CONSULTANT INSPECTION REPORT

MODI REALTY MALLAPUR LLP

GULMOHAR RESIDENCY

Sl. No. **1059**

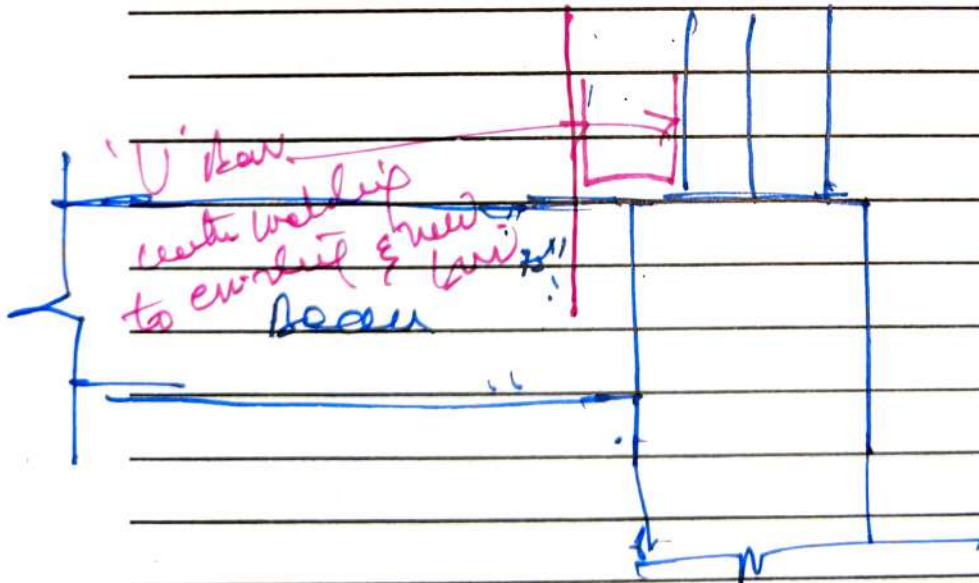
Remarks: column shifted 3rd away
from original position @ Block H
Grid: B.3 column

Shift and location in the plan
